Engine Software Update

GH7 ENG 2011, 2012 and 2013 MY UD-MD

FSB 284-035 Engine Software Update

(February 2014)

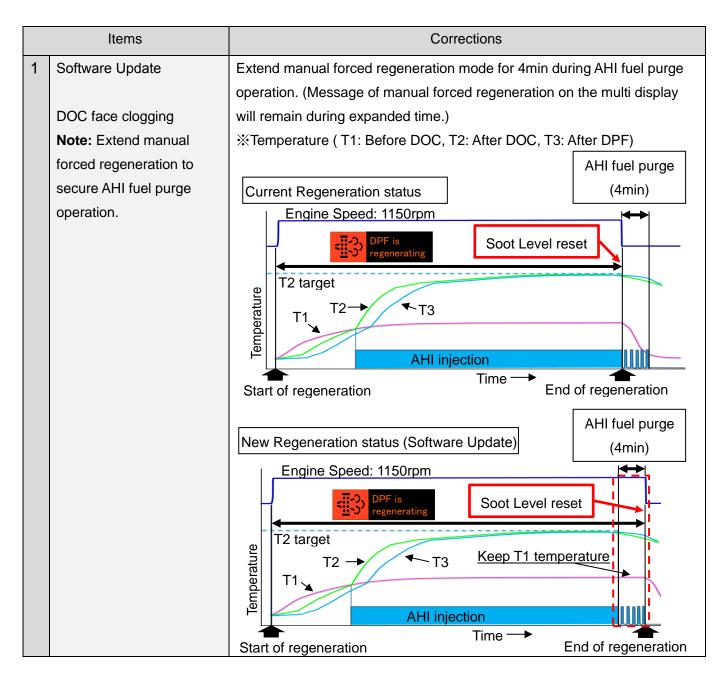
- 1. DOC face clogging.
- 2. Injector out of calibration.
- 3. Soot Bar behavior change during manual regeneration.

Items		Correction		
1	DOC face clogging.	Extend manual forced regeneration mode for 4min during AHI fuel purge operation. (detailed explanation on page 2)		
2	Injector out of calibration.	Engine warning lamp lights up and fault code indicate in cluster when this error occurs.		
3	Soot bar behavior change during manual forced regeneration.	Soot bar remain until manual forced regeneration is completed.
